BIG TREE SUBDIVISION
TEDS Exception Request
August 7, 2006

Re: Design Exception 29-06 – Big Tree Subdivision – 2256 N. 17th Street

DESIGN EXCEPTION #29-06

RE: Big Tree Subdivision: 2256 N 17th Street

PROPOSED DRIVEWAY LAYOUT

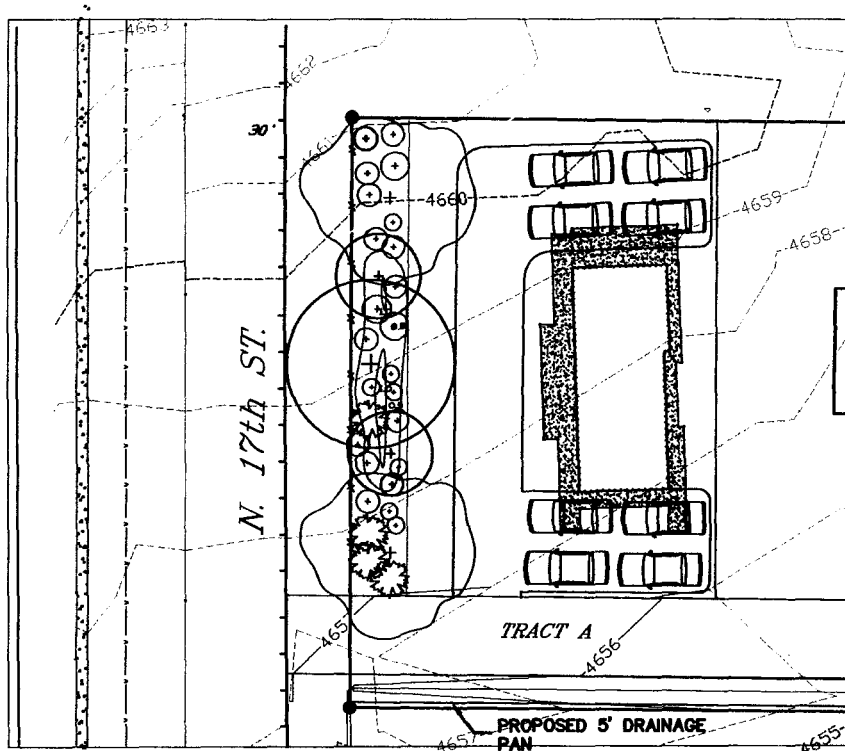
We are requesting to have 5 units (3 single family and the duplex units) access a shared drive or "autocourt" in an effort to reduce the negative impacts on both safety and aesthetics of the neighborhood of breaking up the landscape buffer and possible fencing along N. 17th Street. Section 13.2.1 of the TEDS Manual calls for "not more than four single-family lots to abut or touch any portion of the shared driveway and no more than four single family units may access a shared driveway". It also states that "each lot abutting a shared driveway shall access off the shared driveway...". Unfortunately, the TEDS Manual does not address how a duplex unit under the circumstances found at the Big Tree Subdivision should be handled so we have proposed what we feel is the best solution for the neighborhood, the City of Grand Junction, and the Petitioner.

The proposed design is to allow both units of the existing duplex to use the autocourt for access. Currently the duplex units use a single driveway to access the individual dwelling units so directing that driveway to the proposed autocourt rather than onto N. 17th Street would not drastically change the function or accessibility of the duplex units.

The applicant is requesting to have a shared driveway with 3 single family units and 2 duplex units accessing the driveway, in excess of the 4 single family units as limited by TEDS.

The applicant is requesting variance from TEDS 13.2.1(2) for four single family lots as a maximum off of any shared drive.

If the exception is approved, the requirement for on-site parking for the duplex parking should be addressed. Four on-site spaces per unit is recommended as a minimum.

Typically we do not have multi-family units access a shared drive. The biggest concern would be available off-street parking.

Staff recommends approval of the exception requested ~~with specific requirement to develop required on-street parking.~~ *AS DESCRIBED ON ATTACHMENT AS "ALTERNATING DRIVEWAY LAYOUT."*

ALTERNATIVE DRIVEWAY LAYOUT

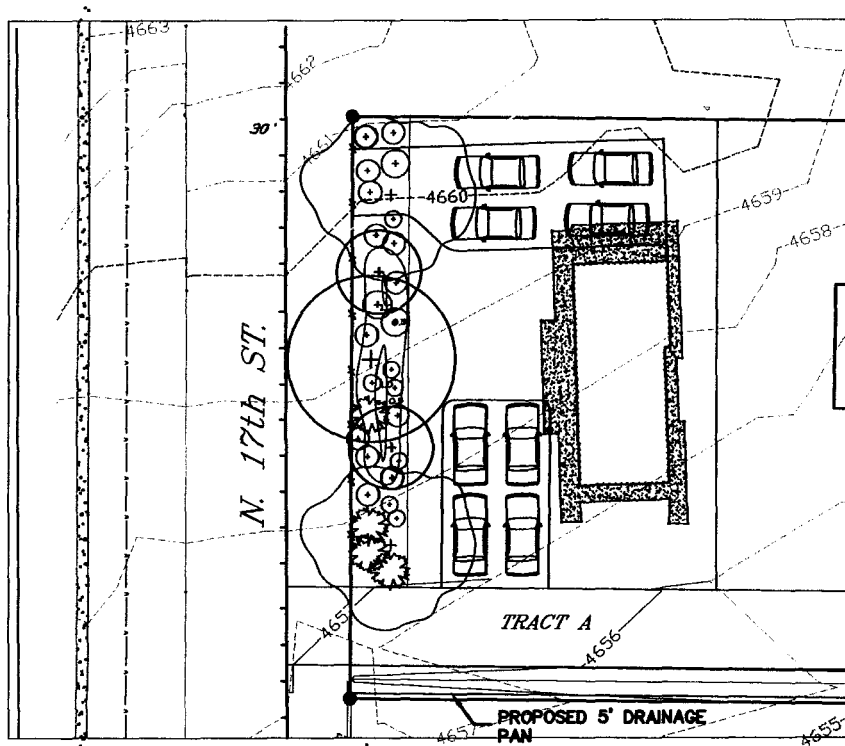
This option does not require a TEDS Exception, but would require 1/2 street improvements

The applicant could consider having the duplex access N 17th, but this would trigger half-street improvements. The half street improvements would aid in the drainage situation but are an additional cost to the applicant.

Please find attached the committee's decision for the above referenced request. This design exception has been approved as modified and as described in the attachment as the "alternative driveway layout." You may use this decision to proceed through the development review process for this exception.
